Subj: FIELD SAMPLING PLAN ADDENDUM AT CORRECTIVE ACTION PLAN SITES
04/19, 06, 14/22 15, 16, 20 AND 25 AT TREASURE ISLAND (NAVSTA TI)

Encl: (1) RESPONSE TO COMMENTS ON THE PHASE 2 SAMPLING FOR THE
CORRECTIVE ACTION PLAN SITES AT NAVAL STATION TREASURE
ISLAND

**RESPONSE TO COMMENTS ON THE
PHASE 2 SAMPLING FOR THE CORRECTIVE ACTION PLAN SITES
NAVAL STATION TREASURE ISLAND**

FIGURE 4
TOTAL TPH IN WATER

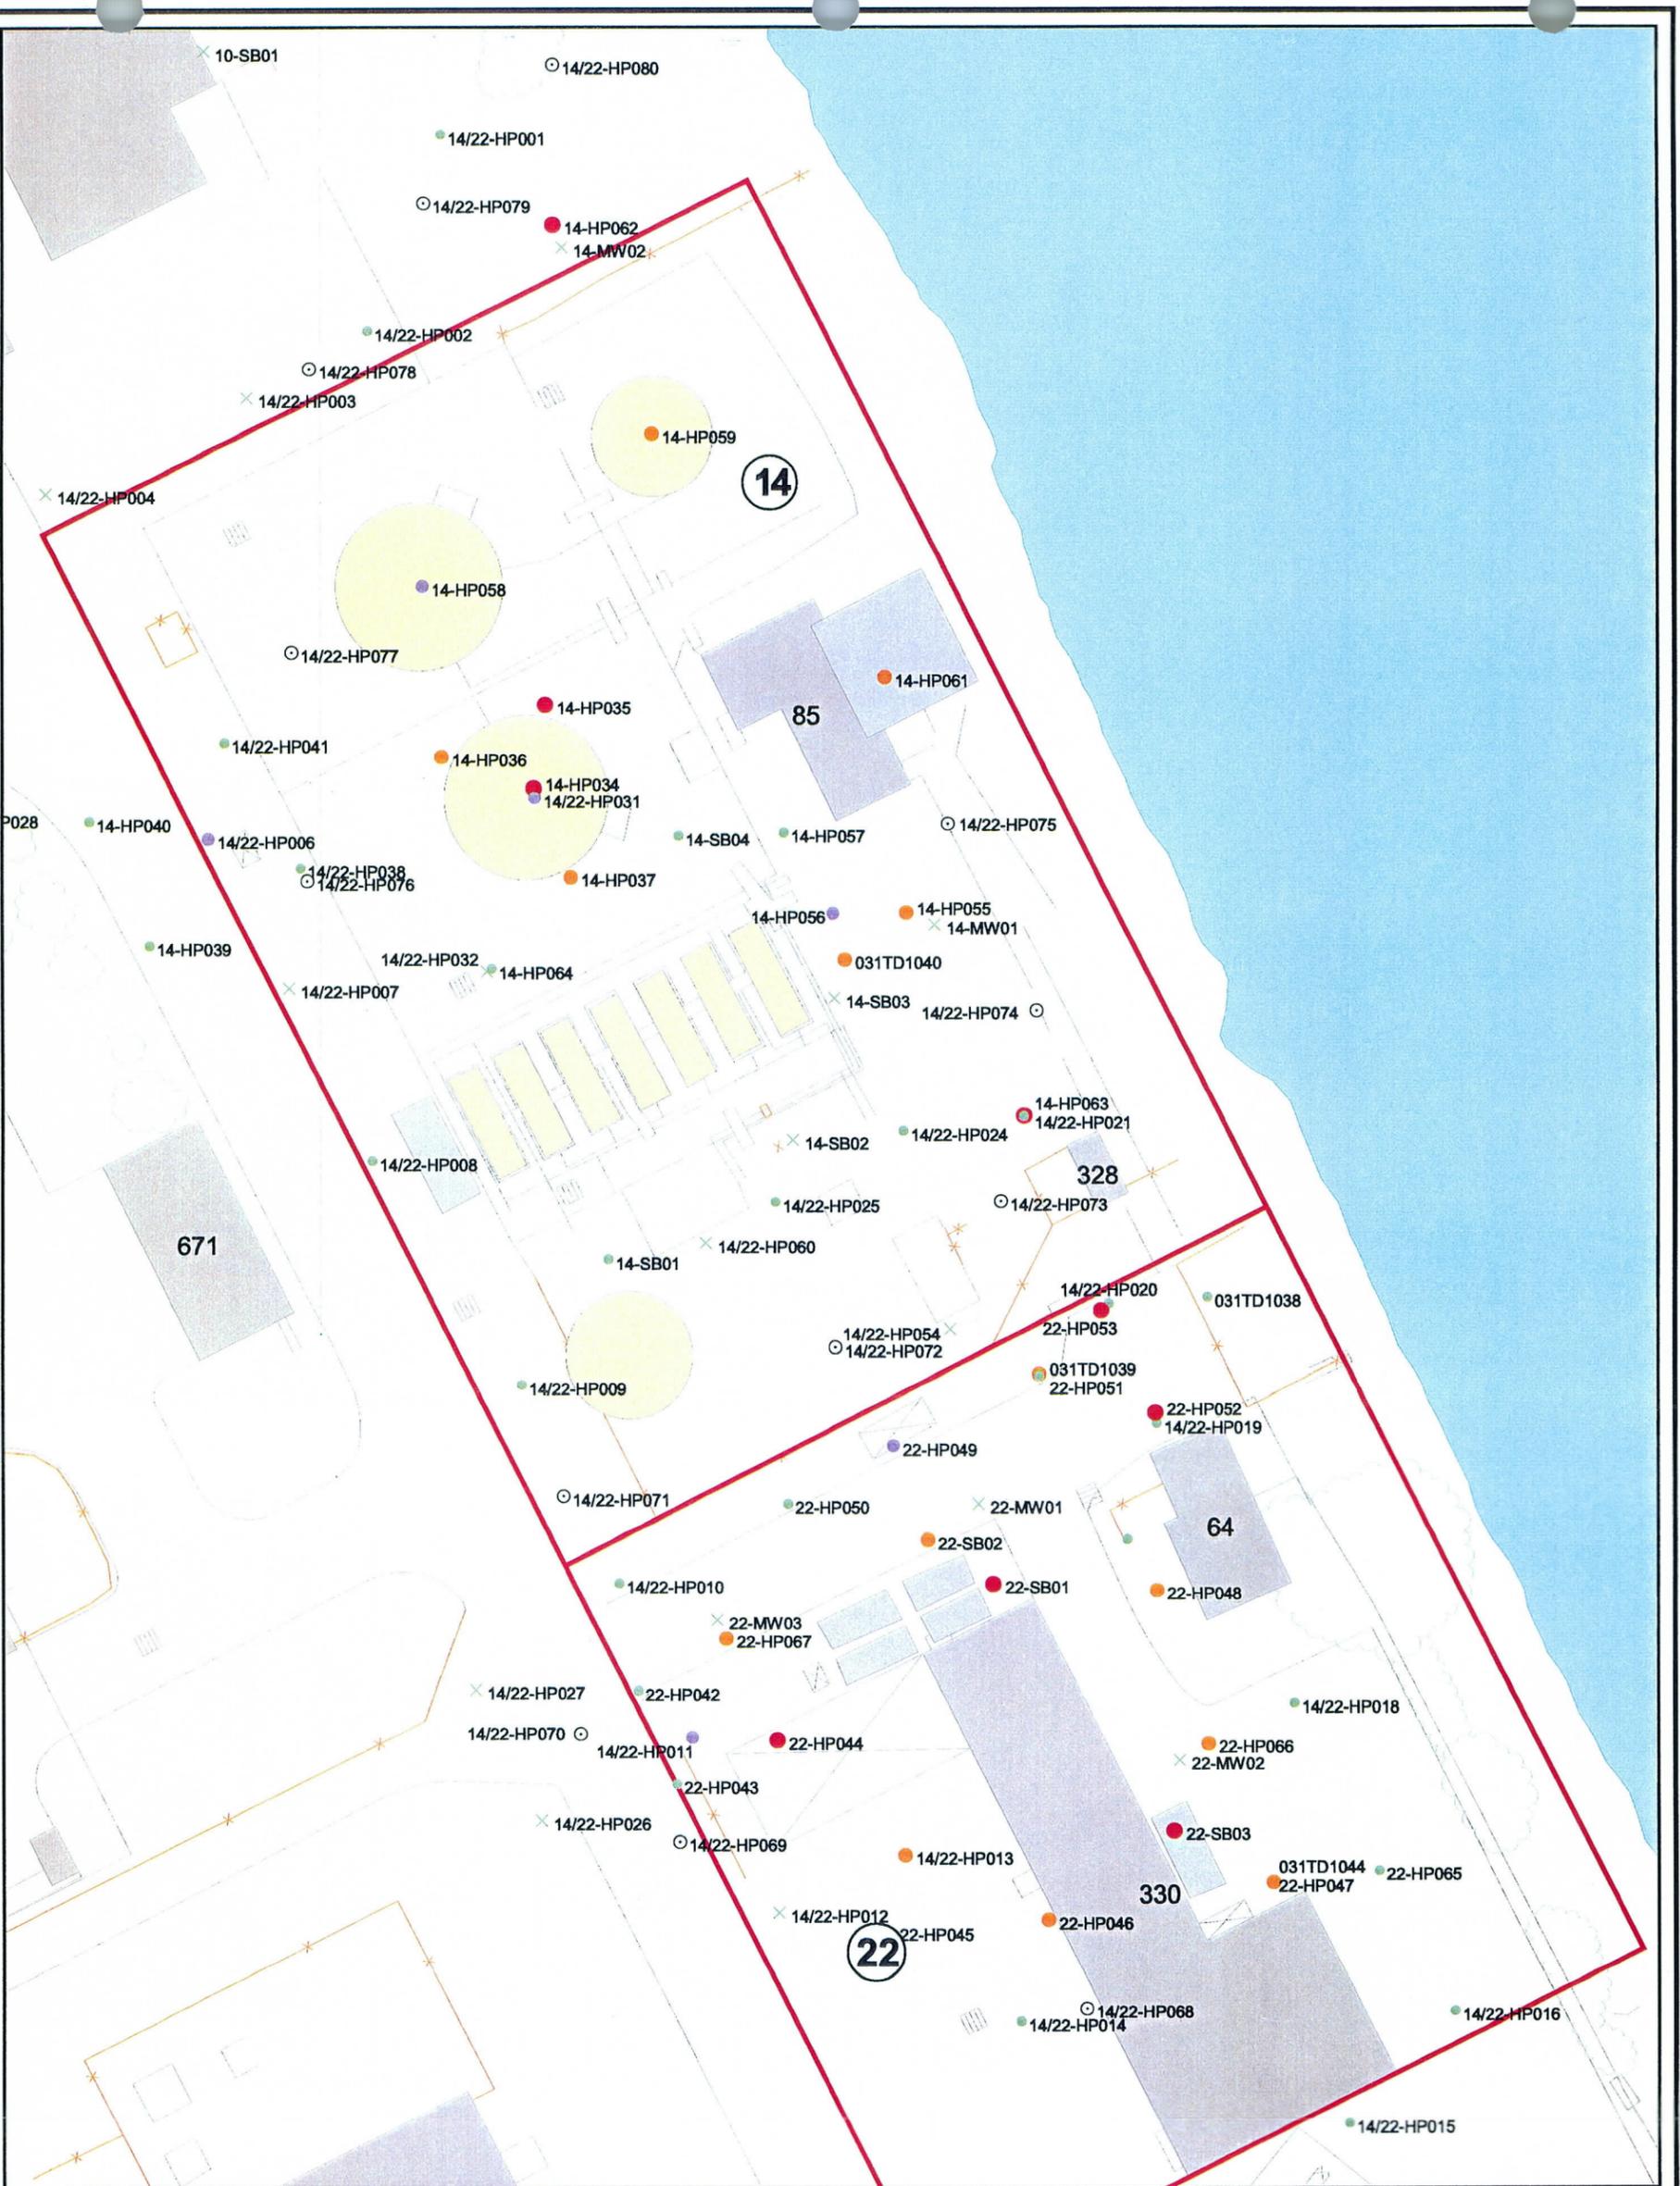
1. **Comment:** I suggest that groundwater sampling and TPH analyses be added to the Navy's proposed sampling and analyses at proposed sampling stations 06-HP074, 075, 076, 083, 084, and 088, where only soil sampling is currently proposed. This will address two concerns. First, it does not appear that groundwater chemical concentrations have been monitored in this area (the northern and eastern boundaries of Site 6) since about 1995, and it is appropriate to collect more-recent data to support remedial decision-making. In addition, TPH was previously detected in this area at concentrations up to 100 mg/l, in Wells 06-MW05 and 06-MW08. Those data were not included on the Navy's figures or addressed by the Navy's current sampling proposal.

Response: In general, once the extent of contamination has been defined using such techniques as Geoprobe™ groundwater grab sampling, the Navy will primarily rely on monitoring well data to characterize the actual groundwater concentrations (especially in lieu of groundwater filtration for extractable TPH [TPH-e]). As such, extensive grab groundwater sampling would not be advocated at Site 6. The vicinity of suggested grab groundwater sampling at locations 06-HP074 and 06-HP075 appears to be reasonably well covered by a recent grab groundwater sample collected at location 06-HP042A and by monitoring wells 06-MW03, 06-MW17, and 06-MW18. Suggested grab groundwater sampling at locations 06-HP076, 06-HP083, and 06-HP084 are unnecessary due to the proximity of these locations to monitoring wells 06-MW03, 06-MW22, and 06-MW21, respectively. The suggested grab groundwater sampling at location 06-HP088 is discussed under the response to site specific comment No. 2, below.

The comment above correctly noted that data for former monitoring well 06-MW05 were not properly posted on Figure 4. Inaccurate location coordinates caused the data for this well to be posted at the same point as monitoring well 06-MW08 (data for well 06-MW05 was obscured). As noted above, the Navy also relied on other figures correctly posting earlier site data to interpret the phase 1 data and proposed phase 2 locations.

FIGURE 6
TOTAL TPH IN WATER

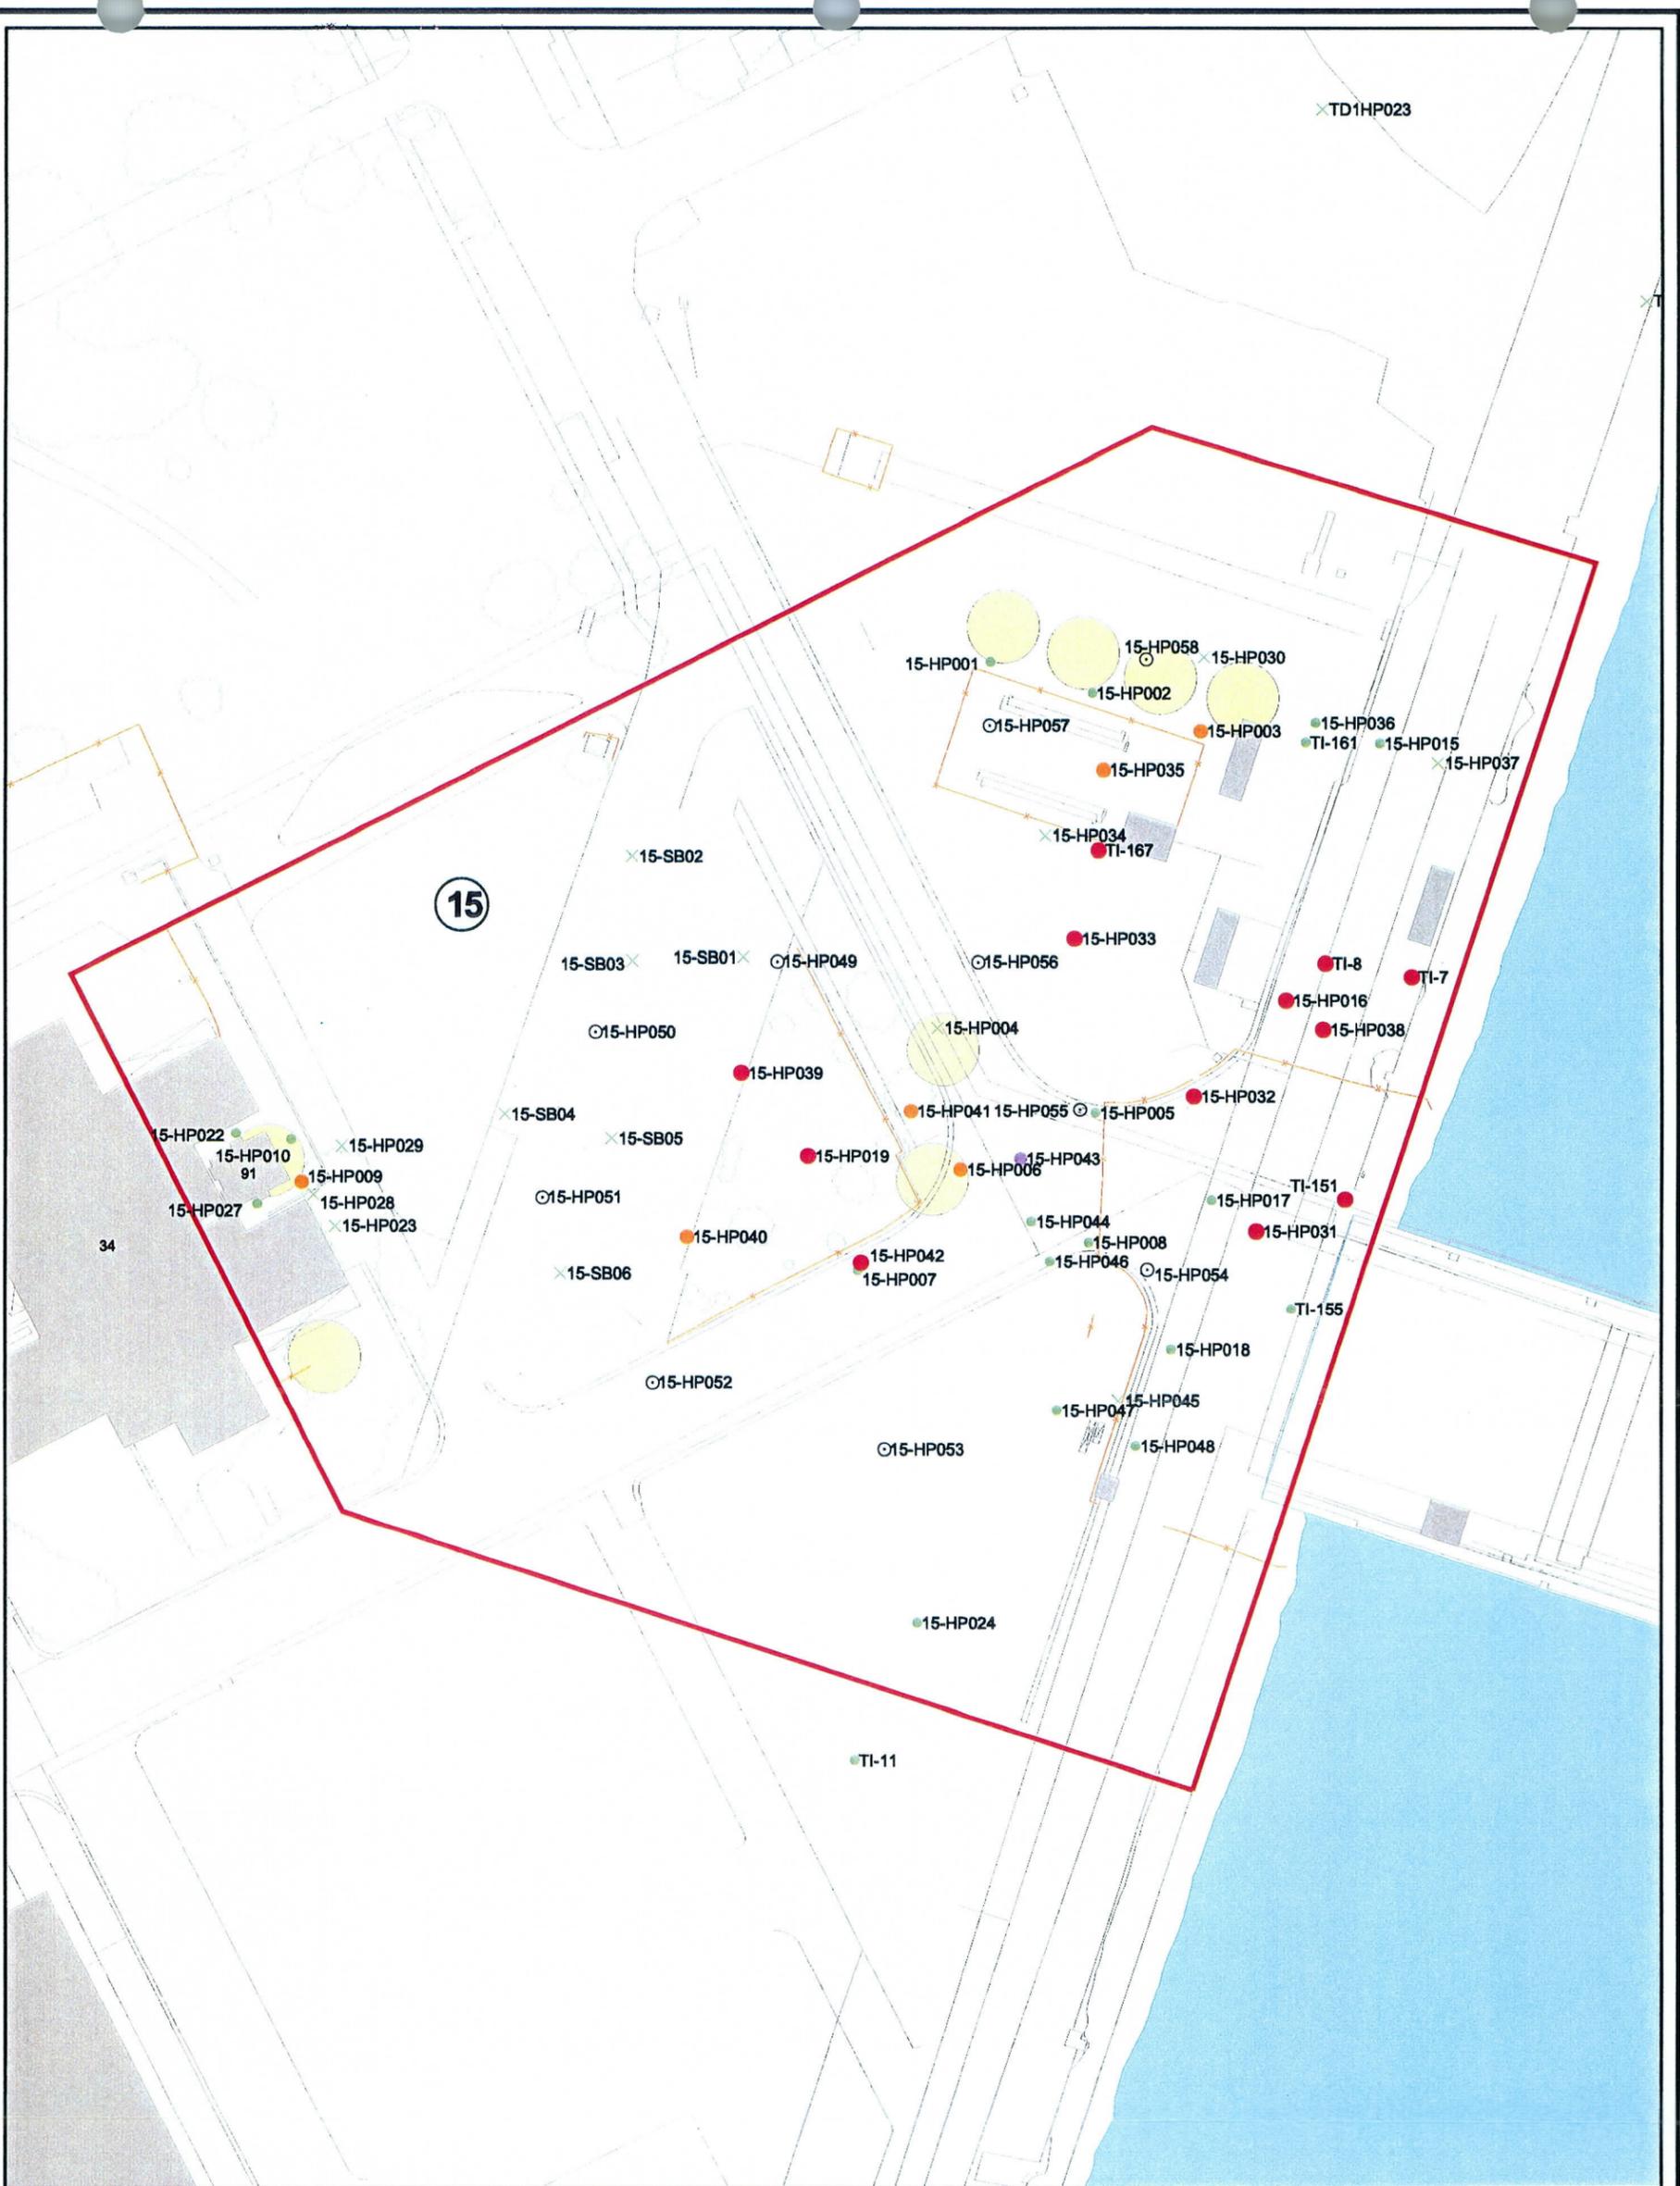
3. **Comment:** I understand from discussion during the site walk that the Navy will conservatively assume that the available TPH data from sampling stations nearest the bay (e.g. 14-HP 061 and 22-MW07) will represent TPH concentrations between those stations and the bay margin, rather than continue characterization within a few tens of feet from the bay. I suggest that we request the Navy to document this remediation-planning assumption or to provide a more accurate description of their approach to site characterization and remediation planning at this site.

Response: Monitoring wells 14-MW05, 22-MW06, and 22-MW07 and boring 14-HP061 were located as close to the shoreline as possible. Location 22-MW07 was in part constrained by utilities, while the other locations were limited by riprap at the shoreline. No particular remedial planning should be inferred from the location of groundwater sampling points along the shoreline, and the Navy did not intend to imply during the site walk on May 17, 2000, that the distance of these points from the shoreline was in some way related to a remedial strategy.
